Phase 2 – Transportation Facility
Stanton ISD
Stanton, Texas

BGR ARCHITECTS, INC.
LUBBOCK, TEXAS
BGR Job Number: 22104.00
October 15, 2021

ADDENDUM NO. 2:

MECHANICAL ADDENDUM

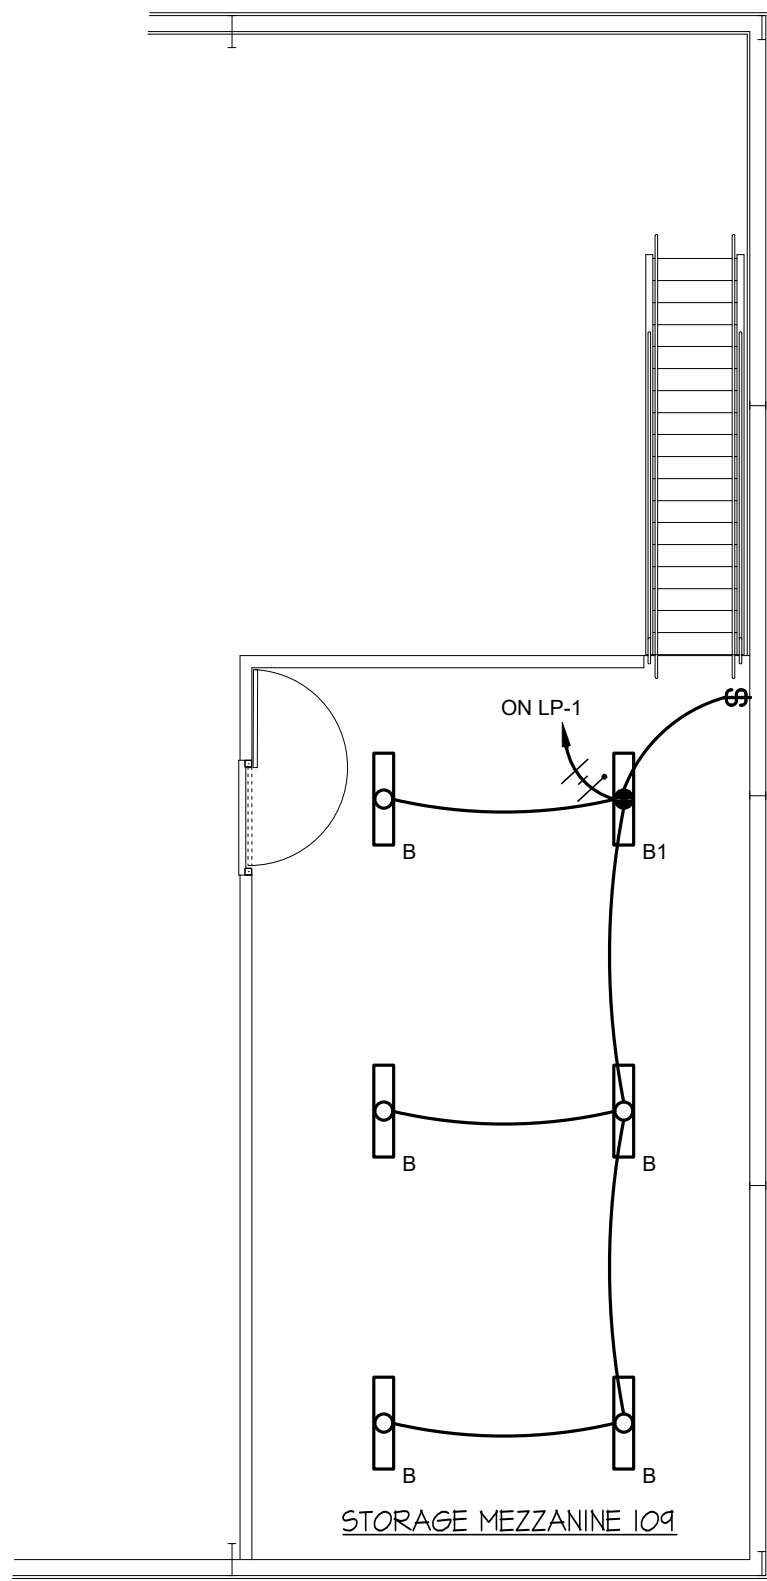
- Item 1: On the drawings, Sheet P101, make the following changes:
- A. Rotate the Pressure Wash Unit (PW) 90 degrees and relocate to the corner of Maintenance 102, below Unit Heater UH-3. Extend domestic water piping and natural gas piping to that location.
 - B. On the Plumbing Fixture & Equipment Schedule, for the Pressure Washer (PW), note that the manufacturer and model number shall include the phrase, "Or Equal".
 - C. In Keyed Note #5, change the telephone number to: 806-789-2261. The contact person is Tommy Spitzer.

1/8"sc. FLOOR PLAN - POWER

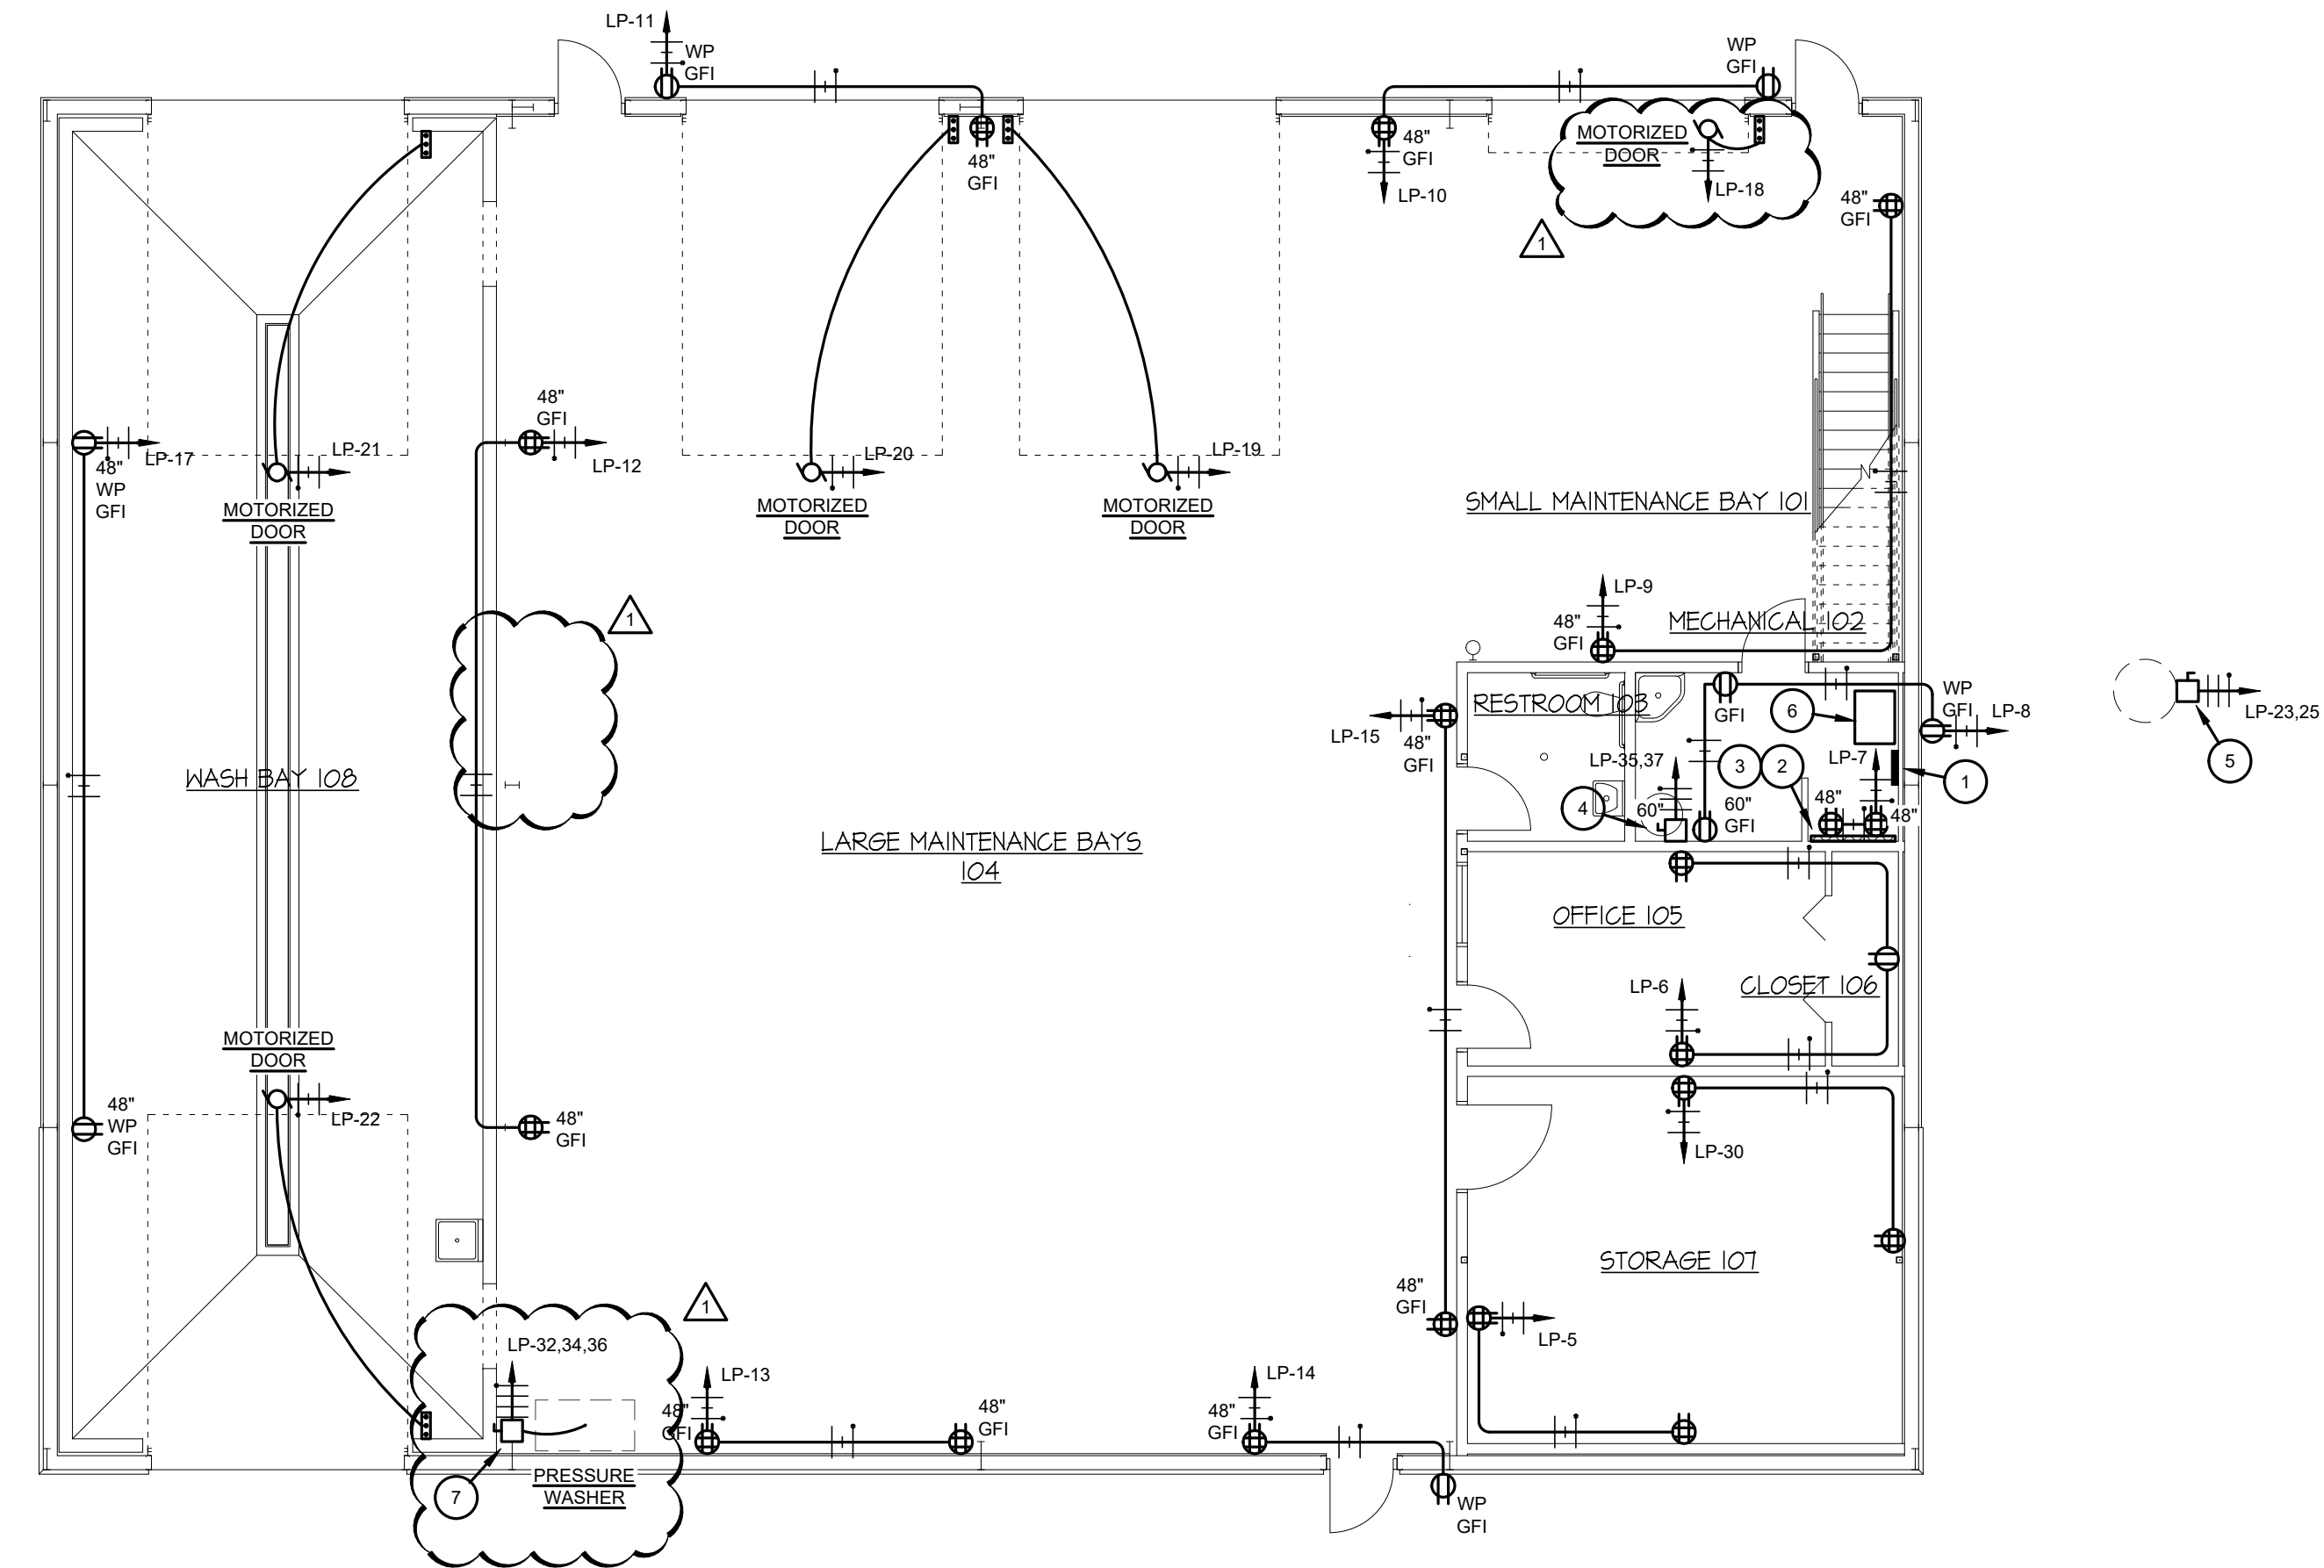
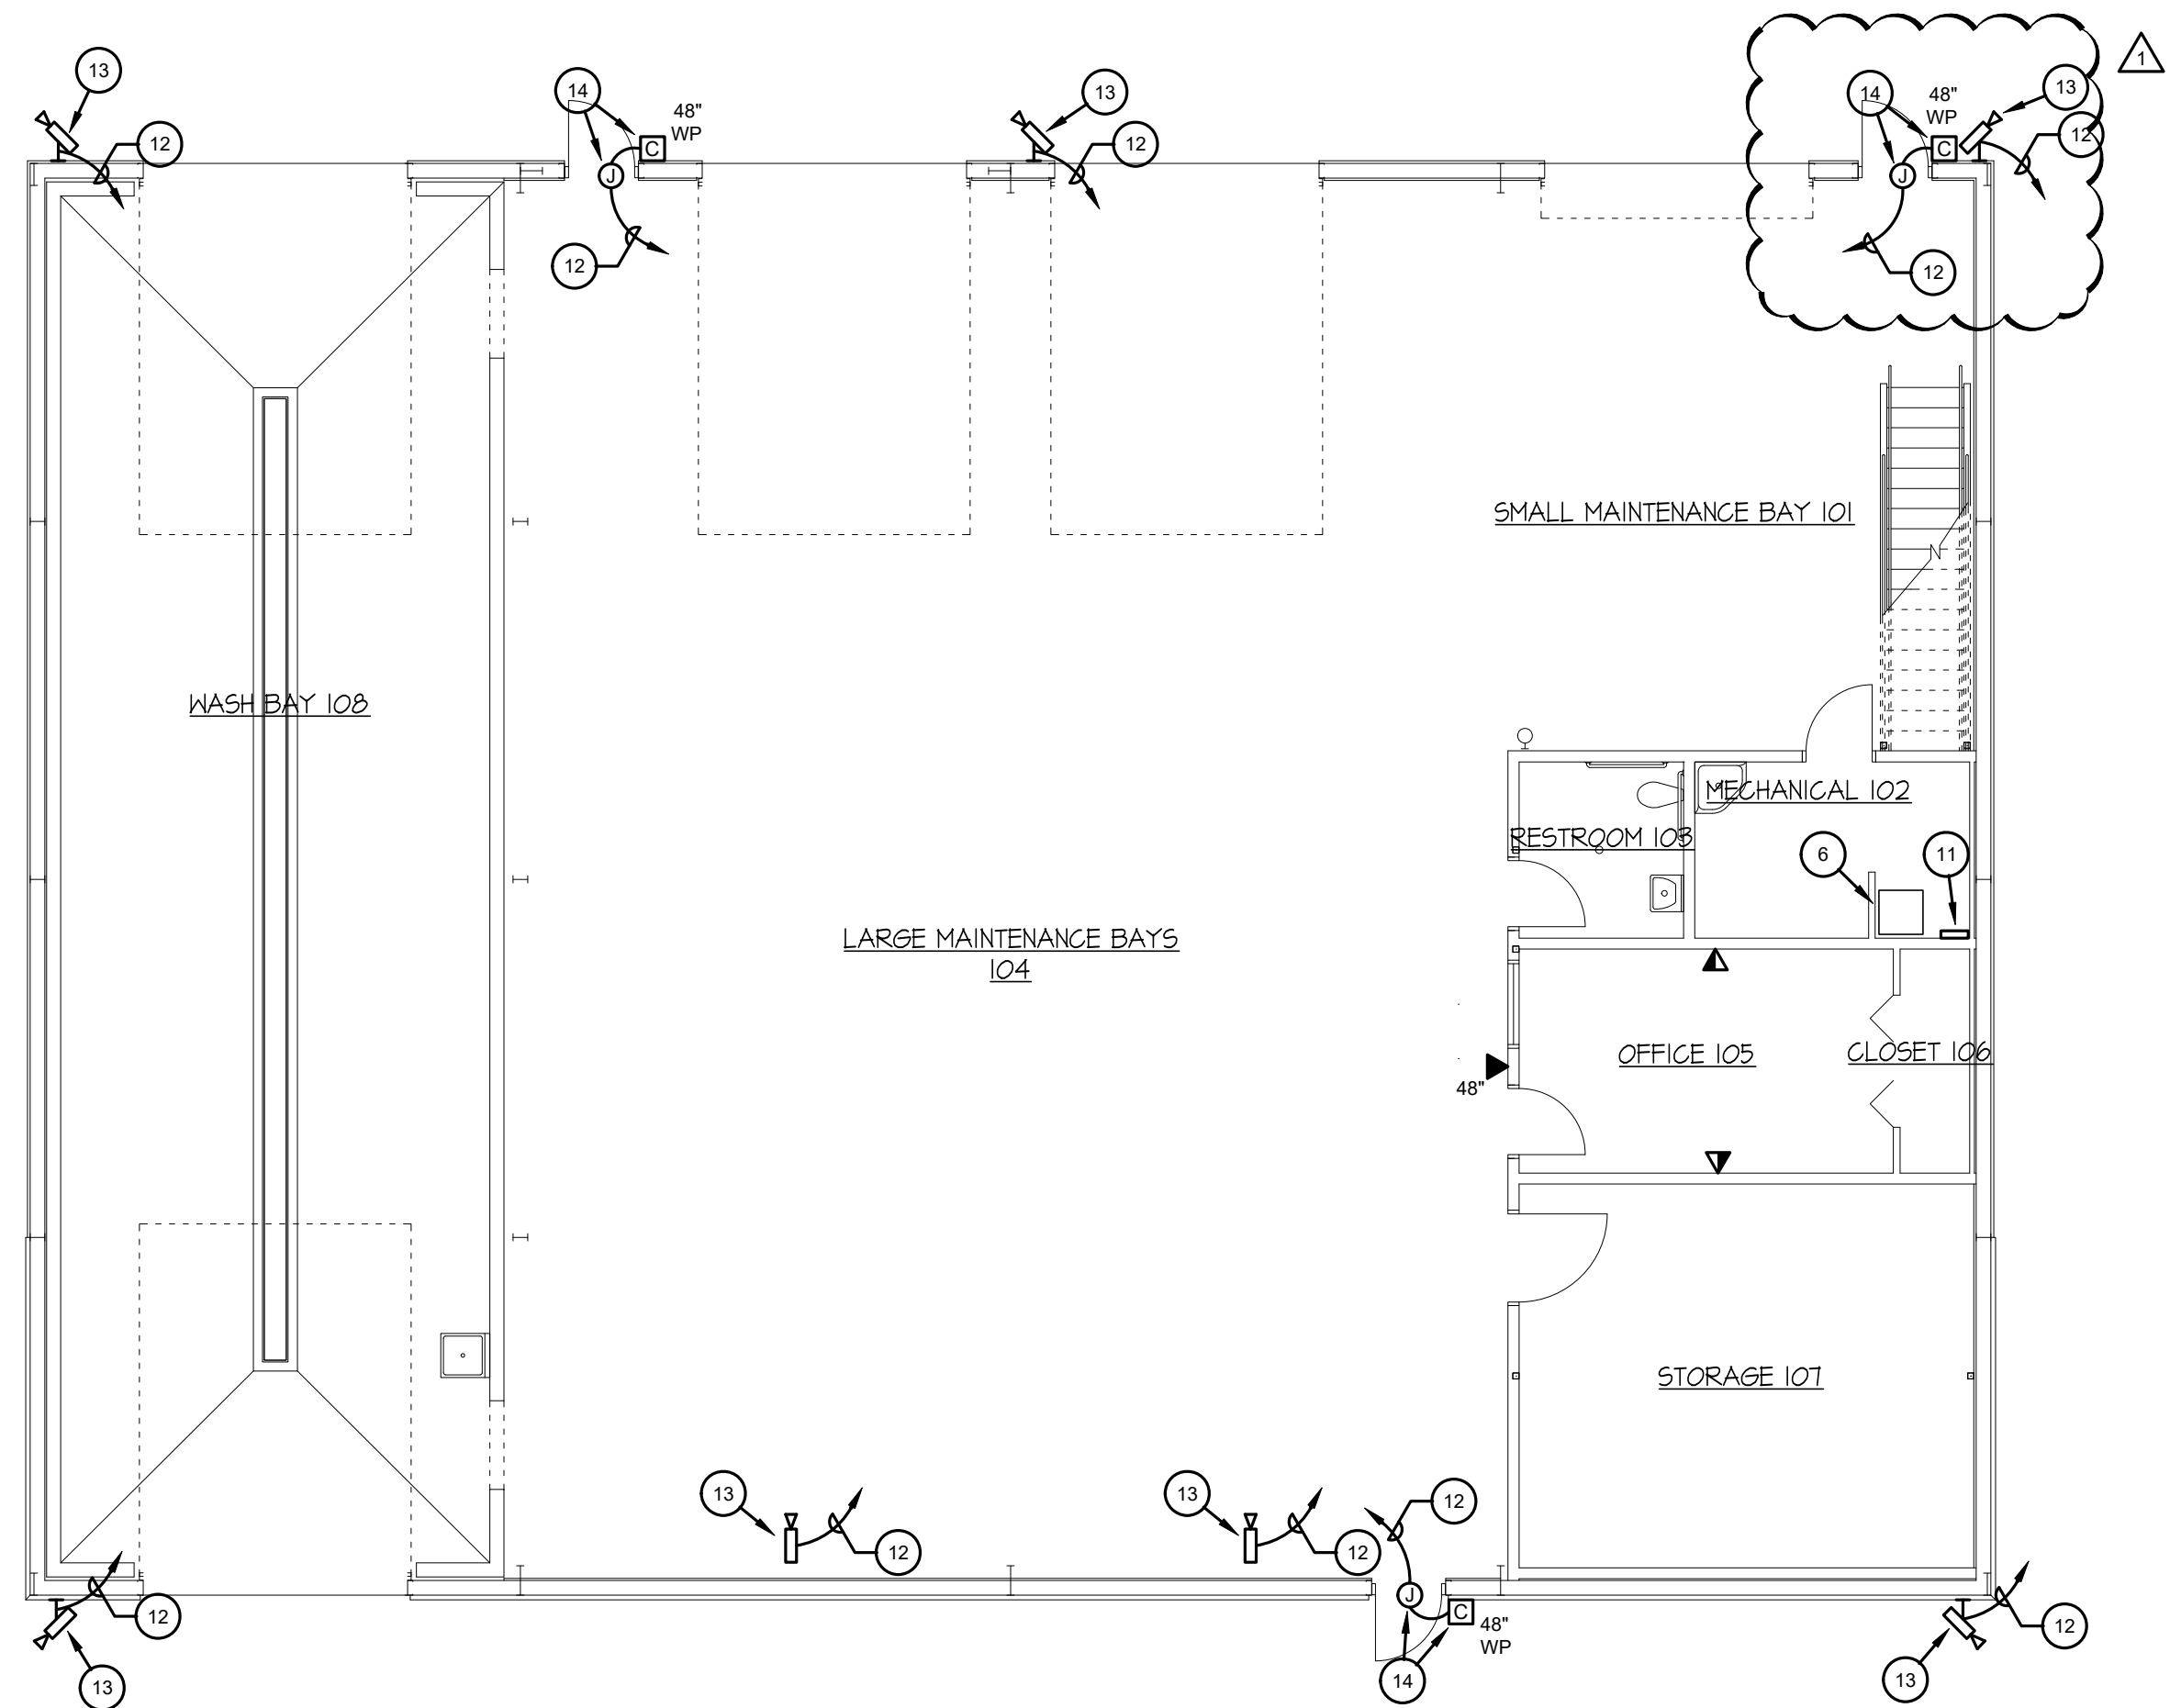
- PANEL "LP" (208V).
- 4' X 8' X 3/4" FIRE RETARDANT PLYWOOD COMMUNICATIONS BACKBOARD.
- PROVIDE AND INSTALL COPPER GROUNDING BUSBAR EQUAL TO HARGER NO. GBIT 14424A2T IN THIS ROOM. CONNECT BUSBAR TO PANEL "LP" GROUNDING BAR WITH A #2 GREEN GROUNDING CONDUCTOR IN 1/2" CONDUIT. REFER TO SPECIFICATIONS SECTION 16050 FOR REQUIREMENTS.
- HORSEPOWER RATED SNAP SWITCH AND RECEPTACLE TO SERVE POWER CONNECTION TO WATER HEATER AND RECIRCULATING PUMP RESPECTIVELY. VERIFY EXACT LOCATION WITH PLUMBING PLANS.
- 30A-3P NON-FUSED DISCONNECT SWITCH IN NEMA 3R ENCLOSURE TO SERVE EXTERIOR MOUNTED AIR COMPRESSOR. REFER TO ES101 AND VERIFY EXACT LOCATION WITH OWNER AT JOBSITE.
- TRANSFORMER "TA" (480V-208/120V).
- 30A-3P NON-FUSED DISCONNECT SWITCH IN NEMA 3R ENCLOSURE TO SERVE PRESSURE WASHER. VERIFY EXACT LOCATION WITH OWNER AT JOBSITE.
